ORDINANCE NUMBER 2016-09

AN ORDINANCE OF THE TOWN OF PARADISE VALLEY,
ARIZONA AMENDING THE PARADISE VALLEY ZONING
ORDINANCE, Article XXII, HILLSIDE DEVELOPMENT
REGULATIONS

Section 1. Article XXII, Hillside Development Regulations, Section 2200- 2209 are hereby
amended (with deletions shown as ~~strikethroughs~~ and additions shown in **bold type**):

FIGURE 2 – HILLSIDE DEVELOPMENT AREA

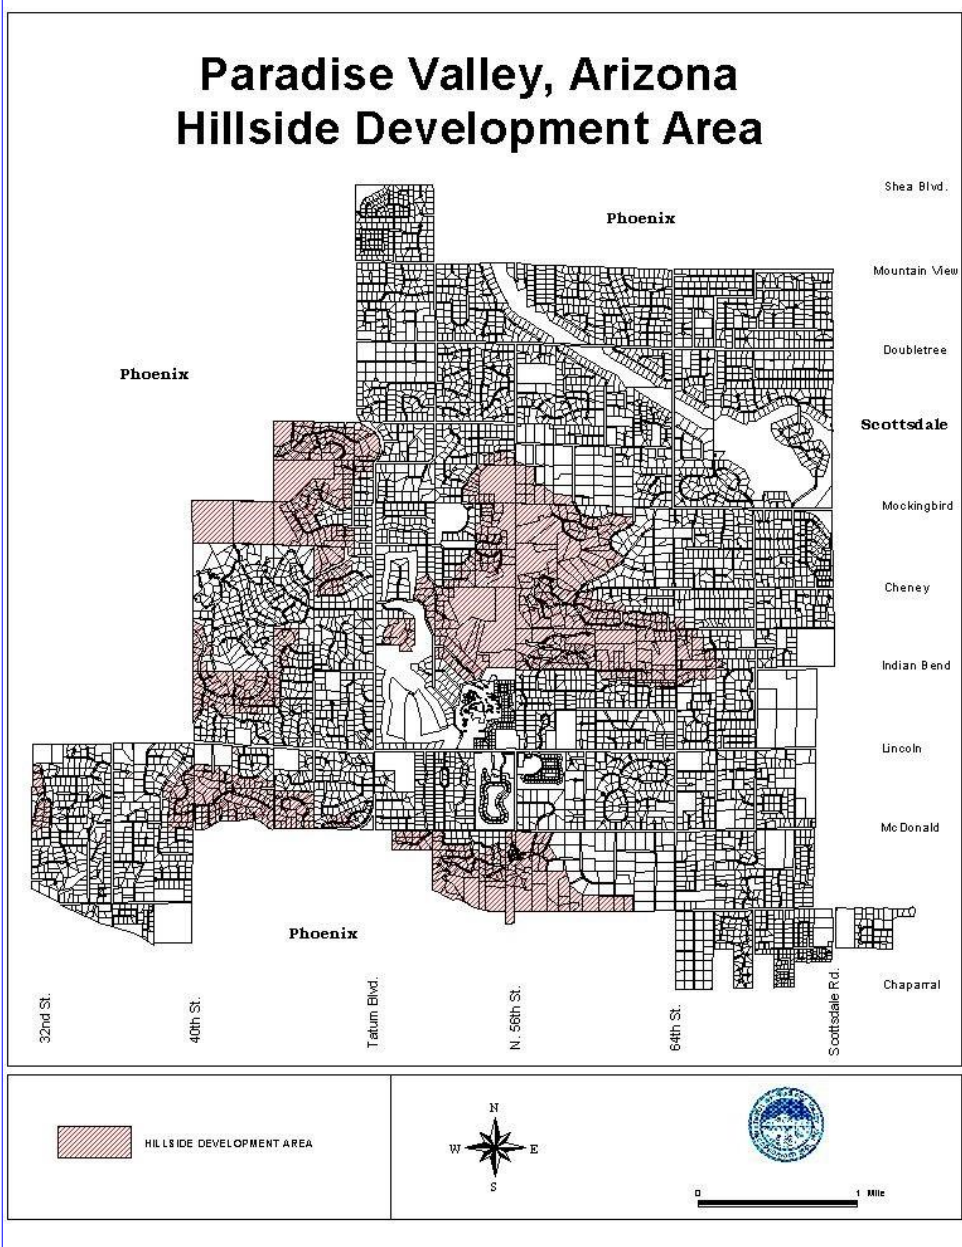
Comment [GB2]: Identify Process to Update Map with any properties removed from Hillside or added to Hillside

FIGURE 5 – BUILDING HEIGHT IN HILLSIDE

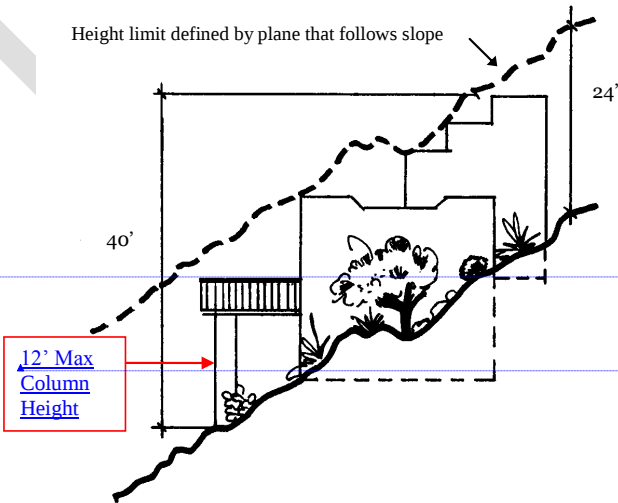
Comment [GB12]: Figure 5 to be updated to reflect these edits.

Comment [GB13]: Update Figure 5 to clarify measurement of 40' maximum height limit.

FIGURE 7 - HEIGHT FOR A CANTILEVERED ELEMENT

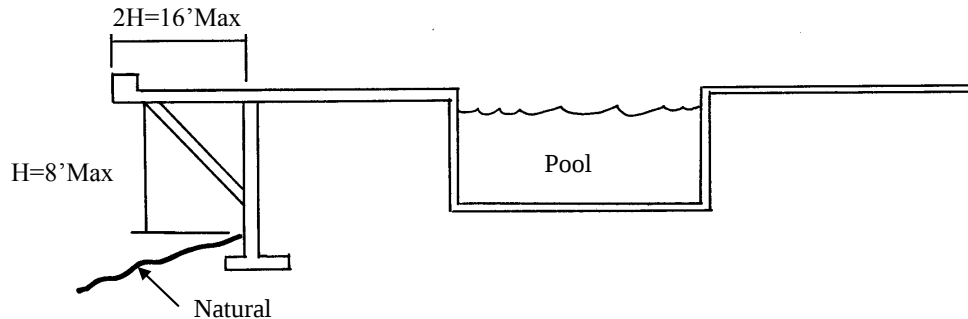
Comment [GB18]: Remove support from illustration on Figure 7.

FIGURE 8 –TERRACED VERTICAL RETAINING WALLS

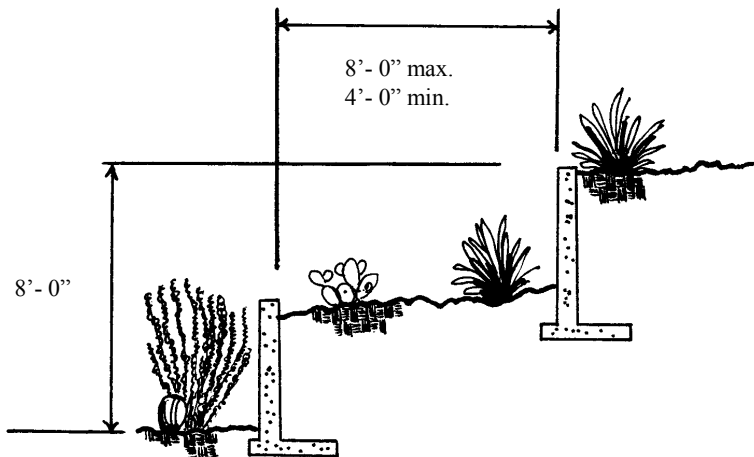
Comment [GB29]: Relocate Figure 8 below the text of 2207.VI.1.e.
